PMSTPCOL PEmails

February 10, 2010
U7-C-STP-NRC-100036

South Texas Project
Units 3 and 4
Docket Nos. 52-012 and 52-013
Response to Request for Additional Information

Attached are the responses to the NRC staff questions included in Request for Additional Information (RAI) letter numbers 299 and 302 related to Combined License Application (COLA) Part 2, Tier 2, Sections 3.7.1, 3.7.2 and 3.8.4.

Figure 03.07.01-20a

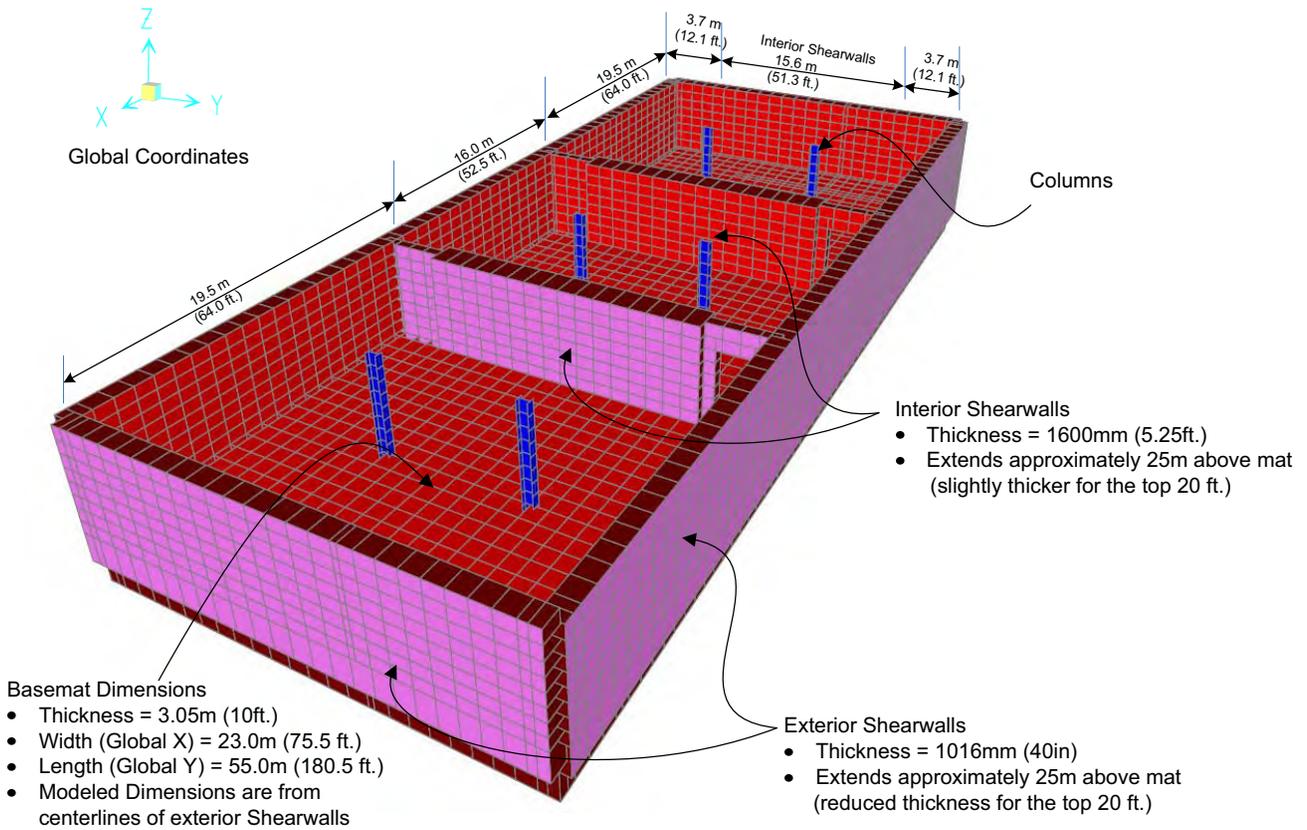
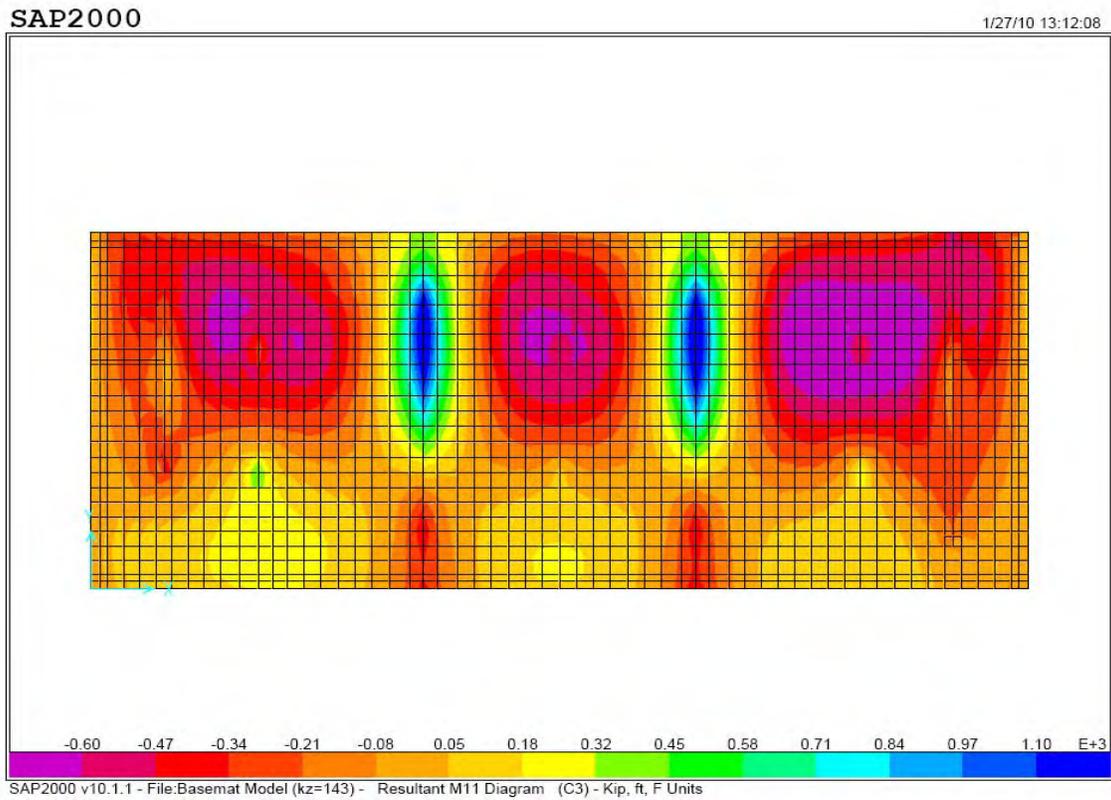
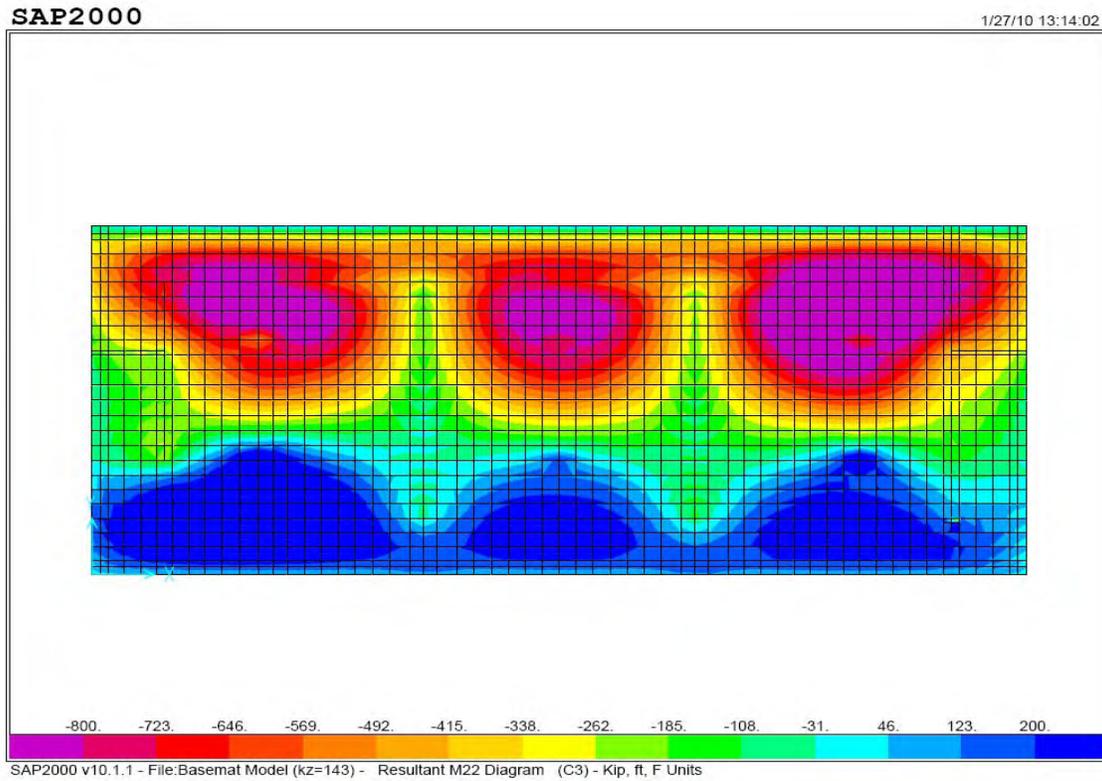
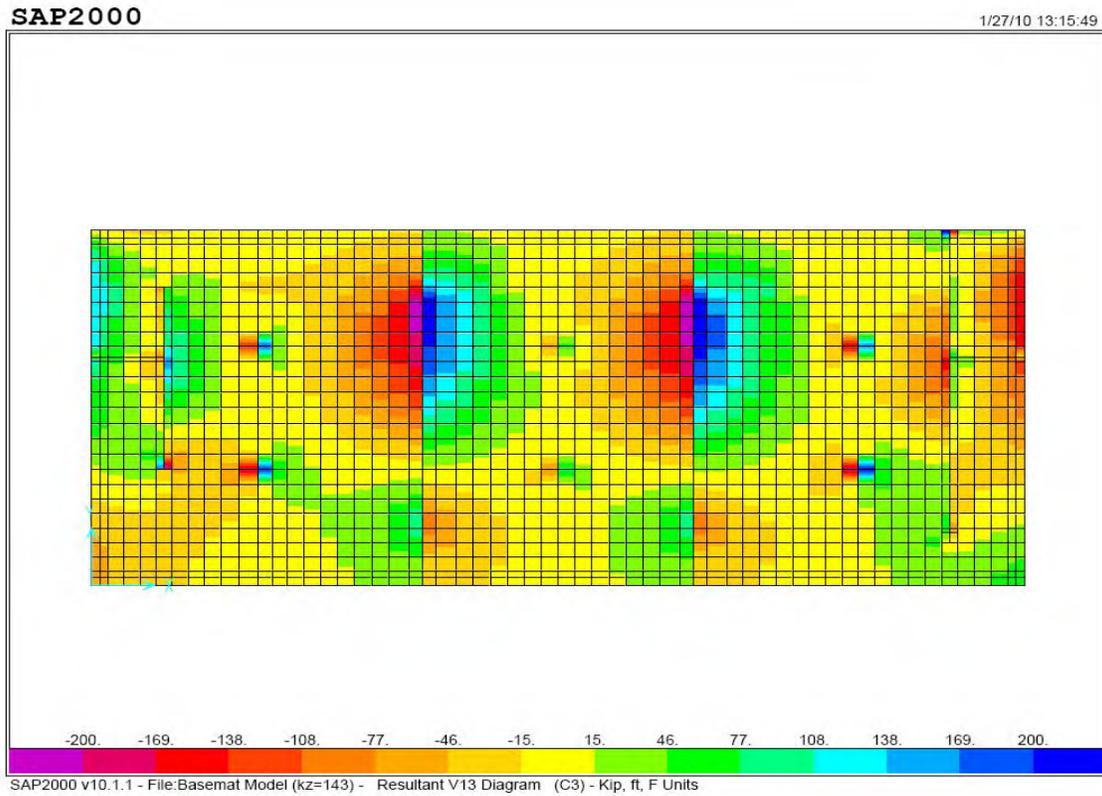
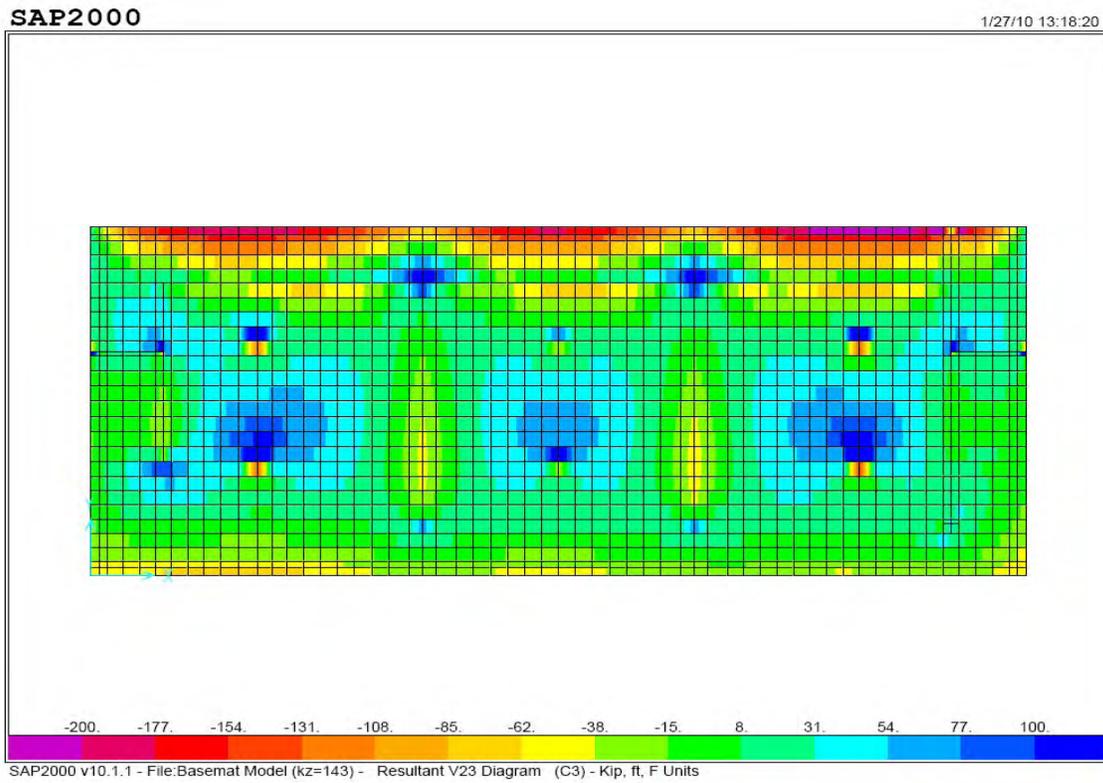
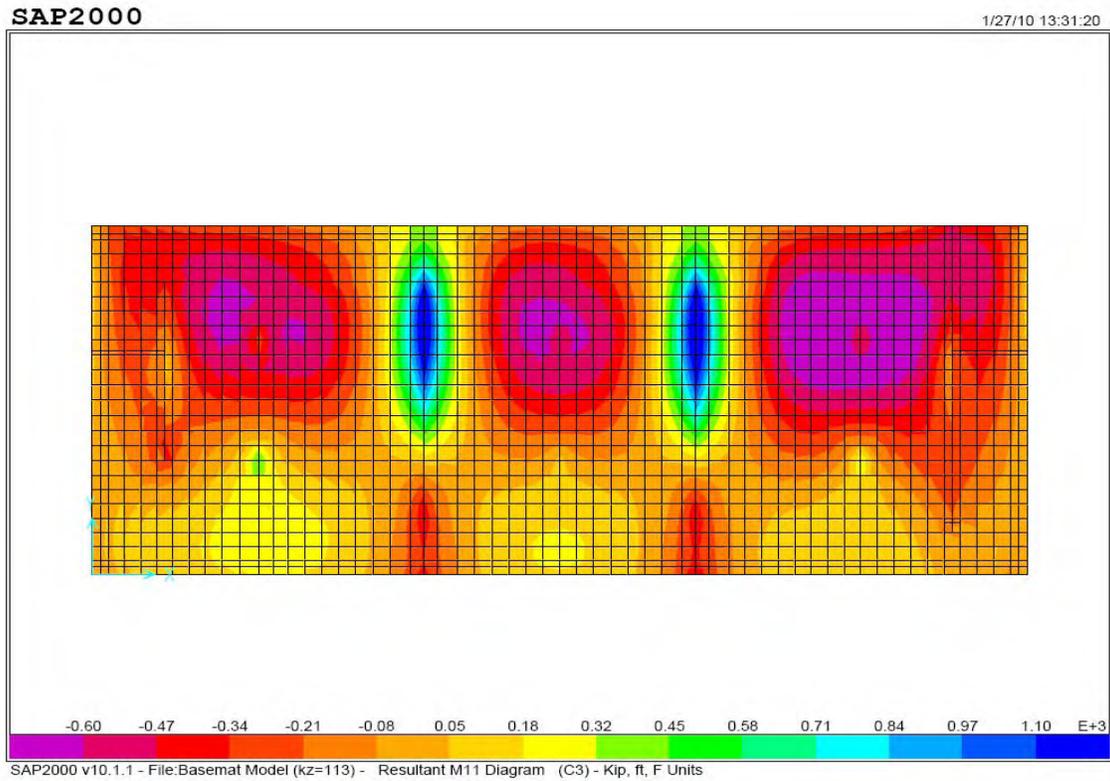
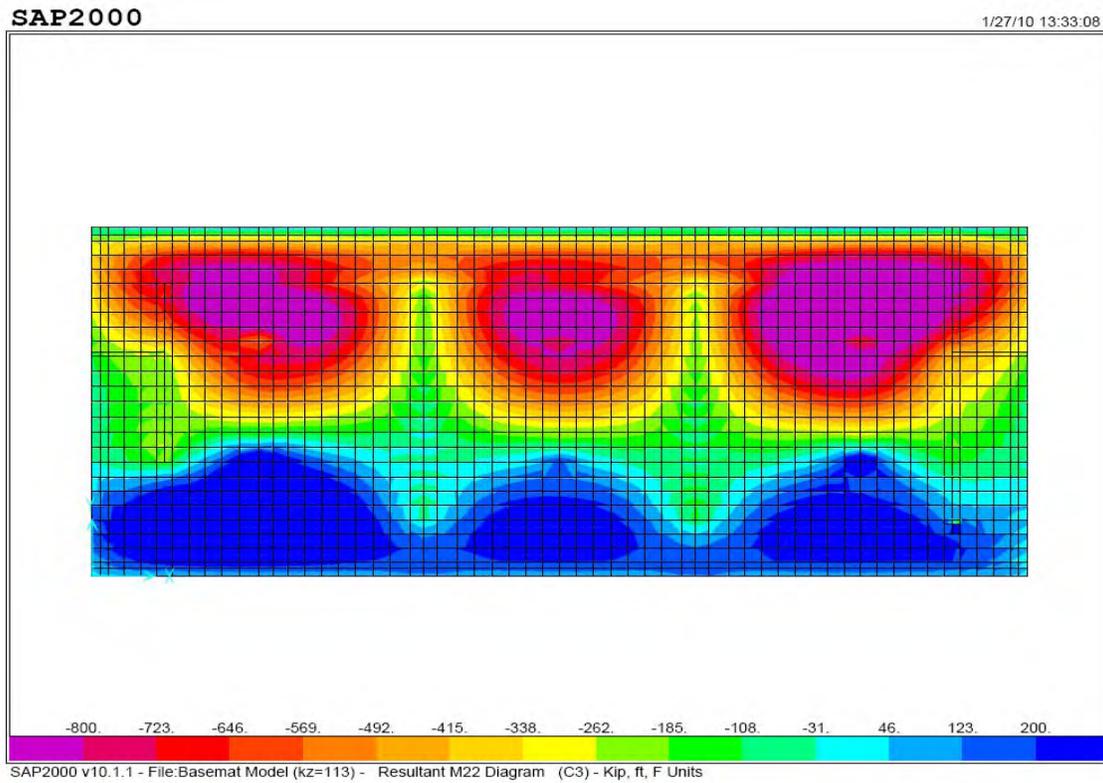
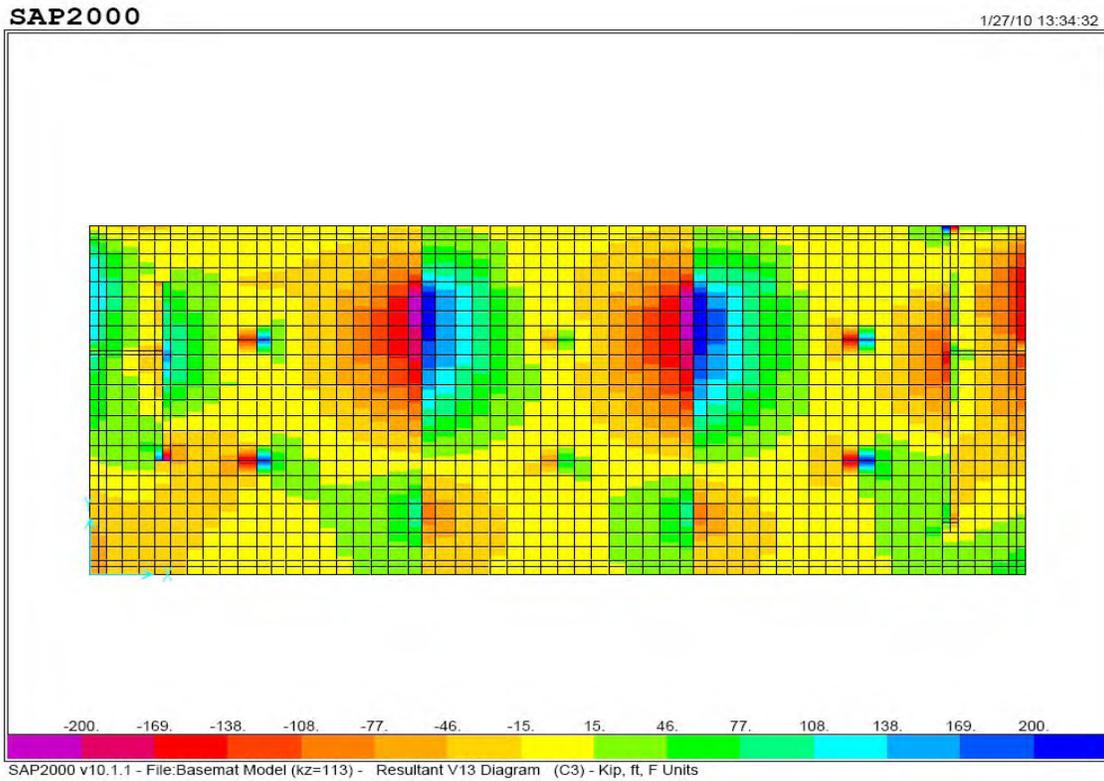
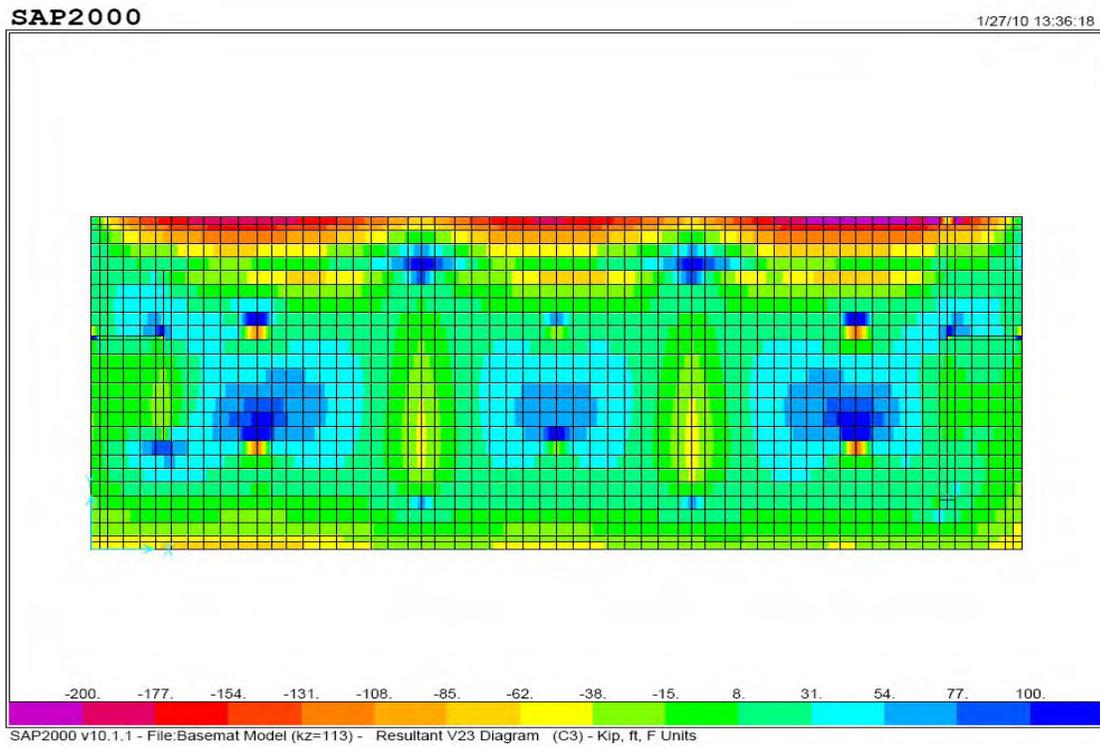
- (2) In the response to RAI 03.07.01-7, the applicant stated that "*The spring constant values are provided only for the Reactor Building in the DCD. Therefore, a comparison of the spring constant values is provided only for the Reactor Building.*" This justification for not evaluating the effect of site-specific shear wave velocity on the Control Building (CB) foundation design is not acceptable. The applicant is requested to further justify that the design of the CB foundation at the STP site would still be bounded by the standard plant CB design.

As noted in part (2a) of this response, the calculated STP site-specific soil spring constants for the upper range and best estimate cases are the same as, or higher than, the best estimate soil spring constants used for the standard design. Higher soil spring constants at the STP site will result in mat design forces smaller than those used for the ABWR CB design. The lower range site-specific soil spring constants are lower than the best estimate DCD spring constants. However, even with lower range site-specific spring constants, the ABWR CB mat design is adequate for the STP site for the following reasons:

- Considering the size and geometry of the CB, arrangement of the exterior and interior shear walls, thickness of the shear walls (39 inch exterior walls and 63 inch interior walls), and the mat thickness (i.e. 118 inches), the CB mat design is quite rigid and not so sensitive to spring constant values. This can be seen from the parametric study results presented in Figures 03.07.01-20a through 03.07.01-20i provided with this response.

Figure 03.07.01-20a shows the layout of the mat and the shear walls of a structure with very similar arrangement to that of the DCD CB. The model used for this parametric study is a three dimensional finite element model. This model was analyzed twice for the total dead load of the structure along with significant seismic moment about the X-axis (along East-West), once with DCD best estimate spring constants and the second time with lower bound site-specific spring constants. Figures 03-07-01-20b through 03-07-01-20e present contour plots of the resulting out-of-plane moments and shears when using DCD spring constants. Figures 03-07-01-20f through 03-07-01-20i present contour plots of the resulting out-of-plane moments and shears when using lower range site-specific spring constants. Comparison of the resulting out-of-plane moments and shears from these two cases show that there is no significant change in mat design forces.

Figure 03.07.01-13a

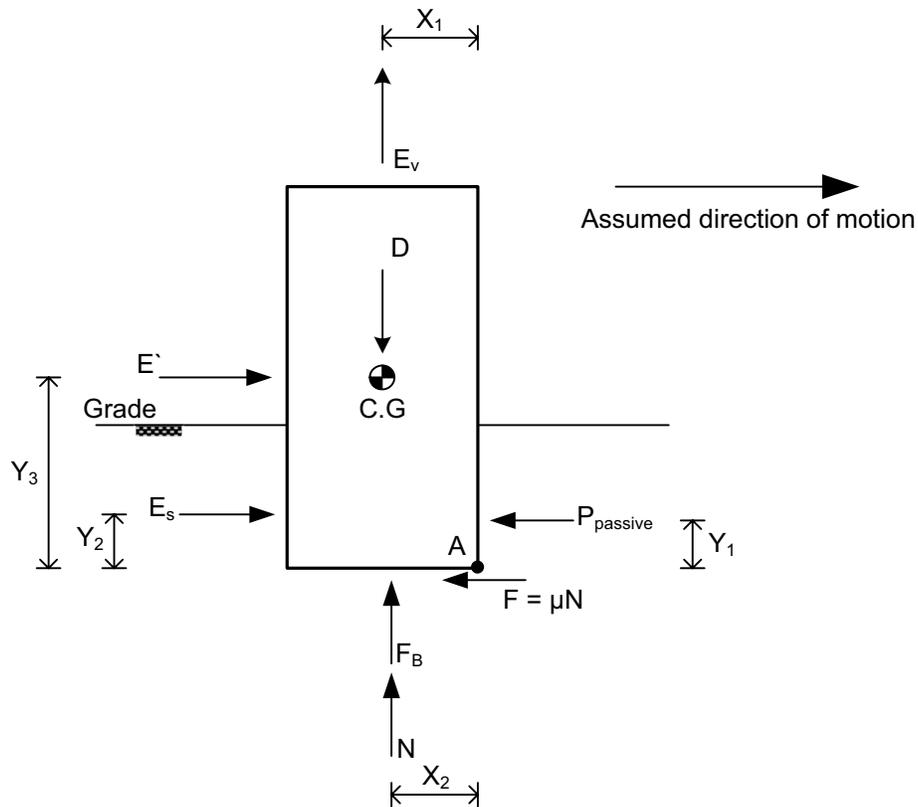
2. The response to item (c) of RAI 03.07.02-1 indicated that non-Category I structures with the potential to interact with Category I structures have not yet progressed to a point where sliding and overturning potential as a result of the SSE can be evaluated. However, as identified in SRP guidance 3.7.2I.8., the staff must review the applicant's seismic design of these non- Category I structures. As such, the applicant is requested to provide in the FSAR factors of safety against sliding and overturning including the basis of coefficient of friction used in the analysis during an SSE for Turbine Building, Radwaste Building, Service Building, Control Building Annex, and Plant Stack.

- Sliding and overturning evaluations are performed as shown in Figure 03.07.03-13a.
- Coefficient of friction for sliding evaluations for the four buildings shall be based on site-specific soil conditions.
- For simultaneous application of seismic forces in three directions the 100%, 40%, 40% combination rule as shown below will be used:

Confirmation that the design meets the minimum required factor of safety for sliding and overturning and the basis for coefficient of friction for the Turbine Building, Service Building, Radwaste Building, and Control Building Annex will be provided by April 30, 2010.

Figure 3H.6-40: SAP Finite Element Model for UHS and RSW Pump House Design

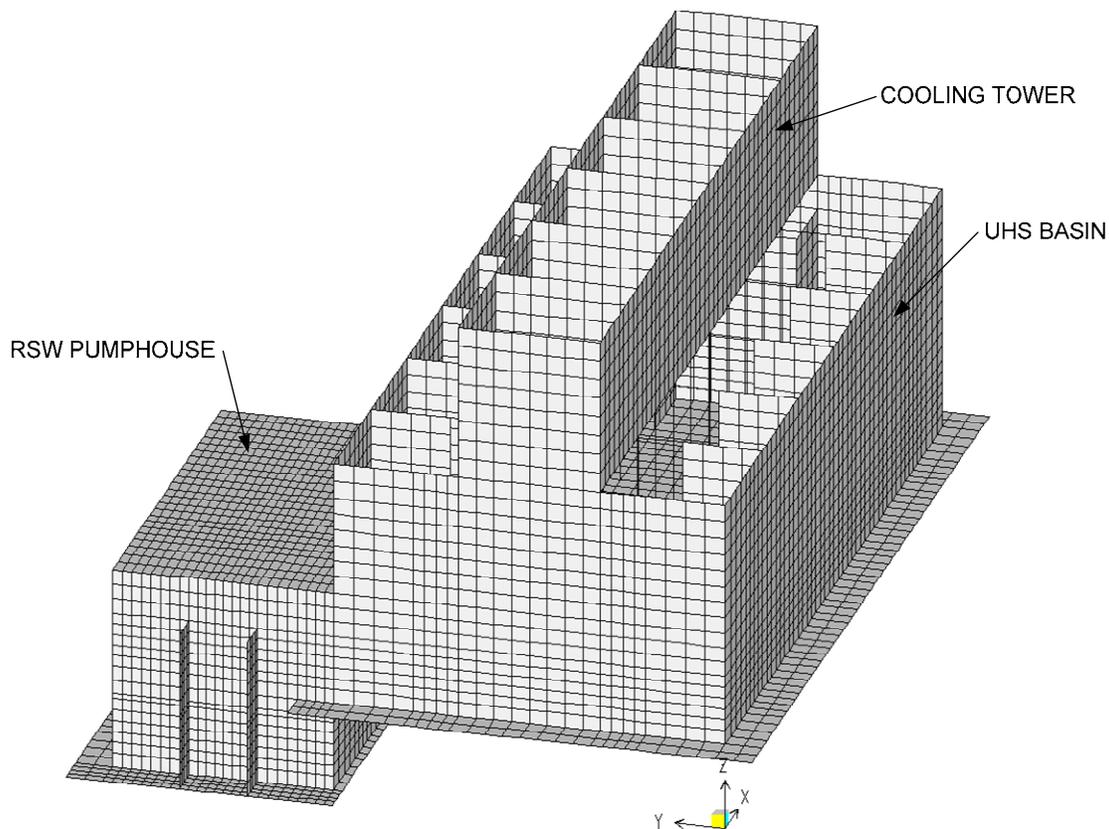
1. The finite element model referenced in Figure 3H.6-40 (this figure is not yet available in the response to RAI 03.07.01-13).
2. Method used to model the backfill material in the SSI analysis.
3. Method used to incorporate the ground water effects in the SSI analysis.
4. The analysis method used to obtain the seismic forces and moments for design evaluations.
5. The analysis method used to model concrete cracking.
6. The analysis method used to assess the effects of soil separation from the walls.

1. Figure 3H.6-40 was provided as part of the Supplement 1 response to RAI 03.07.01-13 (see letter U7-C-STP-NRC-090208 dated 11/19/2009) and for convenience is reproduced below. For additional information and figures for the Soil-Structure Interaction (SSI) analysis model of the Ultimate Heat Sink (UHS) and Reactor Service Water (RSW) Pump House, please see the response to RAI 03.07.02-16 submitted concurrently with this response.
